Access Compliance Report

Public Rights-of-Way

Intersection ID: 11051	Main Street: E_21ST_ST	Cross Street: N_BREVARD_ST	Location: W
ADA ID: 3E4E567C0BC1	Ramp Type: Perp	Initial Pass/Fail: Pass	Overall Compliance: No
		Severity Score: 0

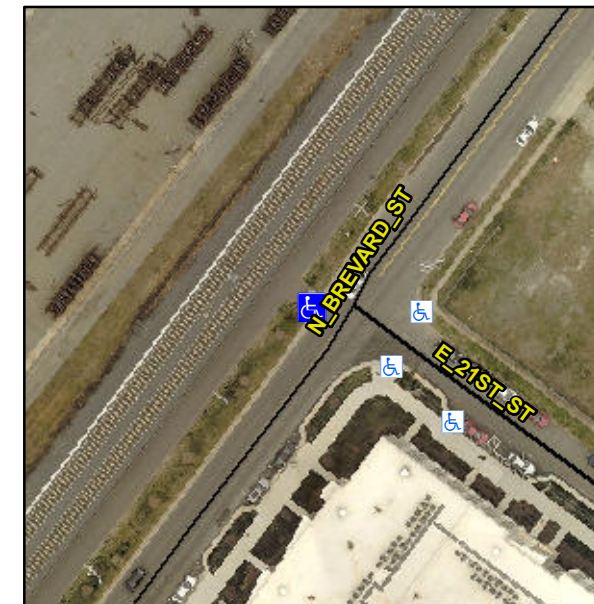
R304.2.2-Perp, R304.3.2-Para

Remove & Replace Landing.
